**Inspection Report
420-426 Pitt Street, Haymarket**

Council investigation officer Inspection and Recommendation Report
Clause 17(2), Part 8 of Schedule 5, of the Environmental Planning and Assessment
Act 1979 (the Act)

**Re: INSPECTION REPORT
'MOSIAC'
420-426 PITT STREET, HAYMARKET ("the premises")**

Re: **INSPECTION REPORT
MOSAIC
420 PITT STREET HAYMARKET ("the premises")**

Figure 1 - Example Boost Pressure signage.

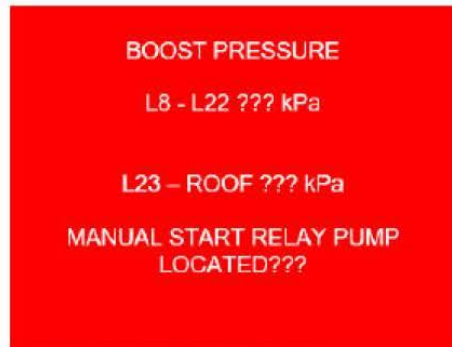
- d. Multiple boost and test pressure signage should be installed at each boost inlet connection for each pressure zone as per Item 1A.B. above. The Zone 2 and 3 boost inlets connection should contain two pressures (see Figures 1 and 2).

- a. In this regard, the installed signage must be water and fade resistant, in accordance with Clause 7.10.1 of AS2419.1-2005. Multiple boost and test pressure signage should be installed at each boost inlet connection for each pressure zone as per Item 1A.B. above. The Zone 2 and 3 boost inlets connection should contain two pressures see figures 1 & 2 below as recommended by FRNSW.
